**2017 Edwards Aquifer Recharge Zone (EARZ) Cured In Place Pipe (CIPP) Construction Contract  
Solicitation Number: CO-00130  
Job No.: 17-4536**

**ADDENDUM 4  
June 7, 2017**

2017 EARZ CPP CONSTRUCTION  
 CONTRACTOR  
**SEWER LINE 012**  
**ERROL ST.**  
**SHEET 1 OF 1**

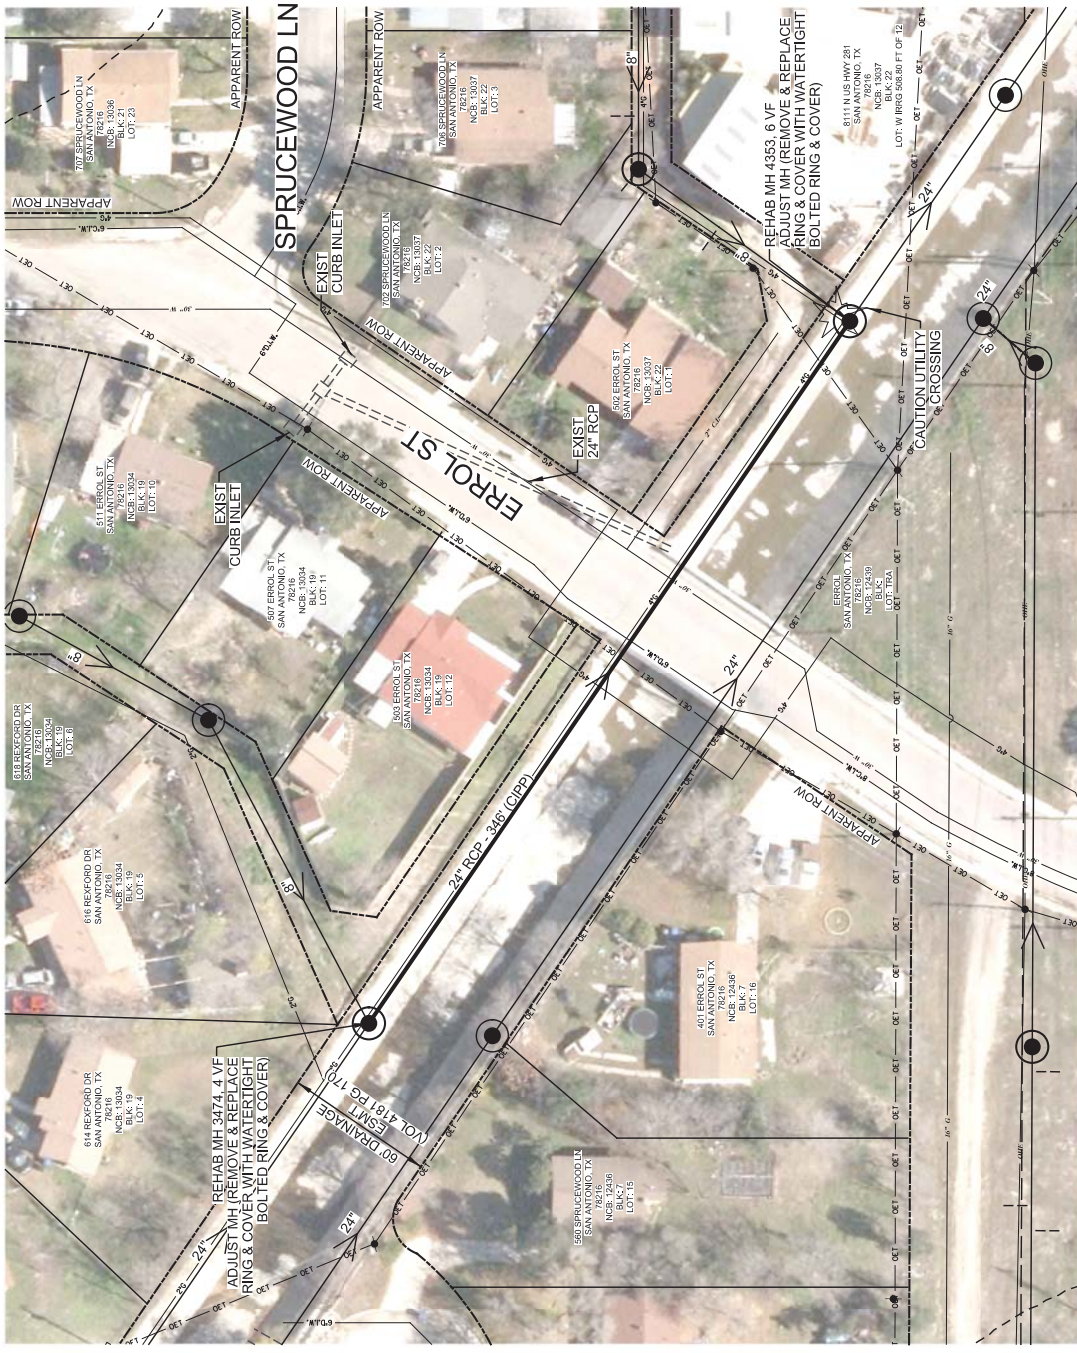
7. Errol & Wurzbach, Sheet 7: Quantity table revised to change bypass description. Title block revised. Remove and replace sheet 7 in its entirety with the revised sheet attached.

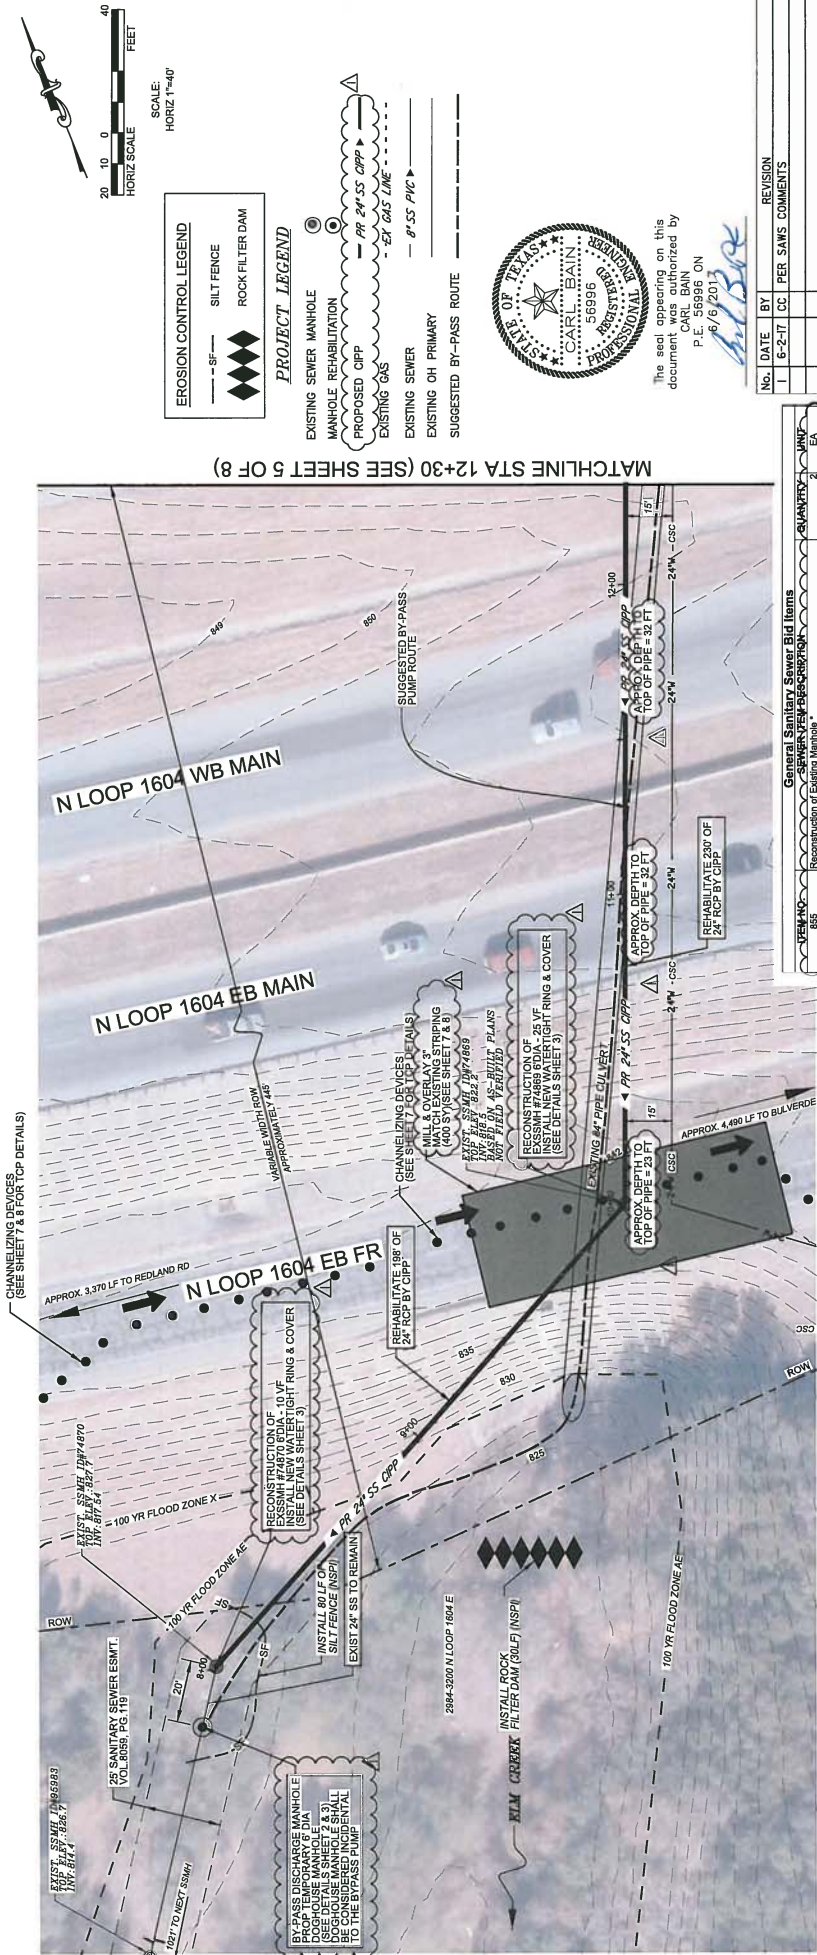
11. New Oak / Loop 1604, Sheet 2: Quantities have been revised to add one (1) additional manhole reconstruction (MH 74869), and pavement repair required for TxDOT roadway repair resulting from MH 74869 manhole reconstruction. Number of sheets updated. Remove and replace sheet 2 in its entirety with the revised sheet attached.

**TRAFFIC CONTROL PLAN**  
**LANE CLOSURES ON**  
**DIVIDED HIGHWAYS**

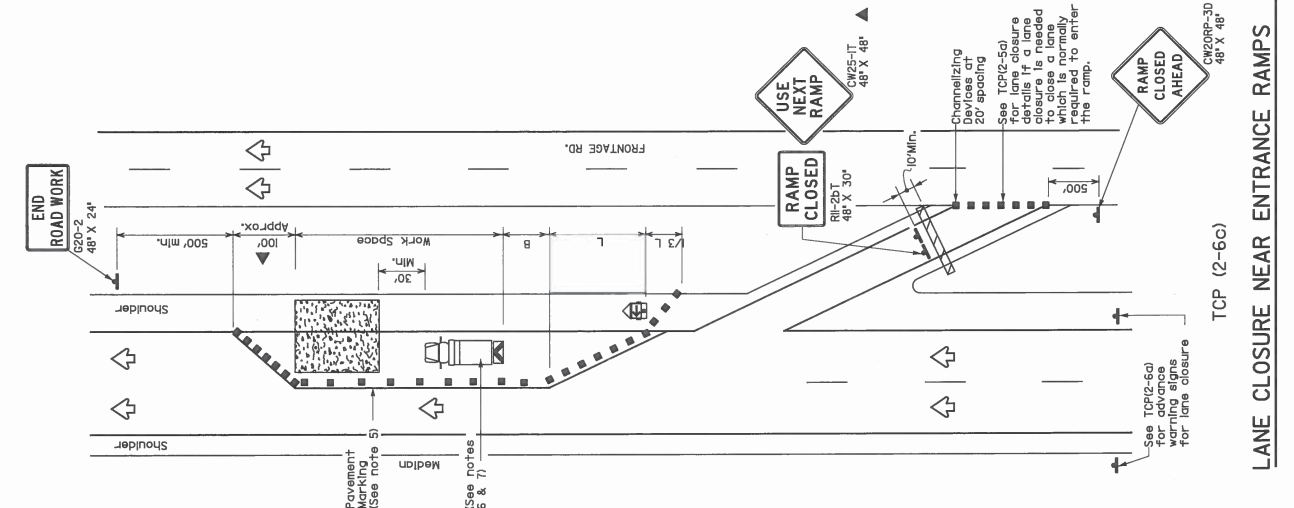
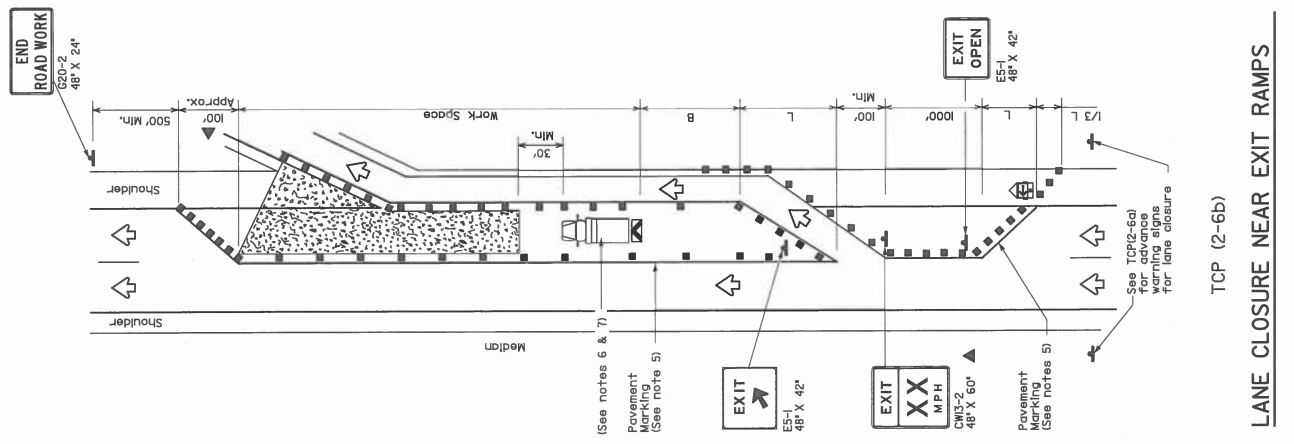
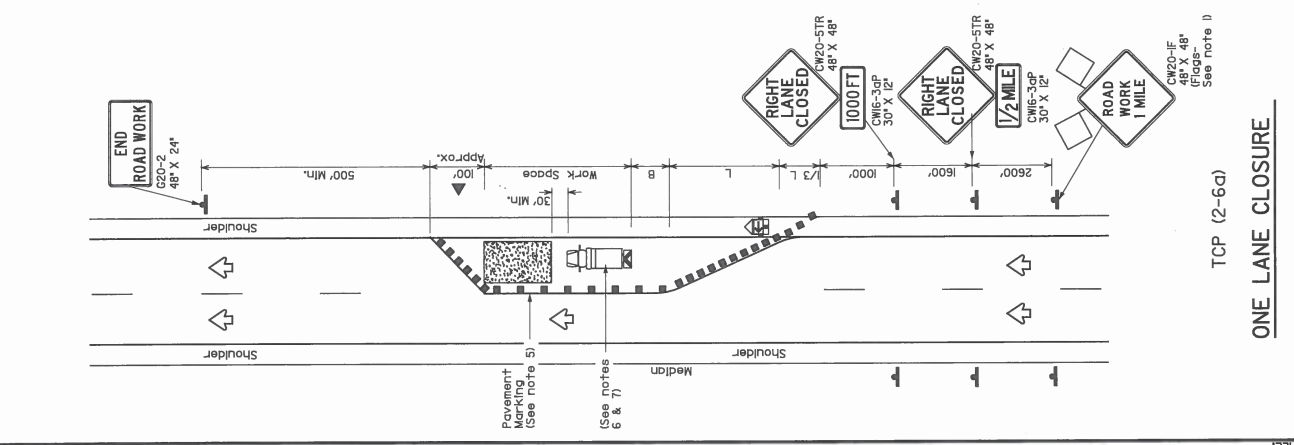
16. New Oak / Loop 1604, Sheet 7: Number of sheets updated. Remove and replace sheet 7 in its entirety with the revised sheet attached.
17. New Oak / Loop 1604, Sheet 8: Additional sheet to address traffic control for surfacing operations. Add the revised sheet attached.
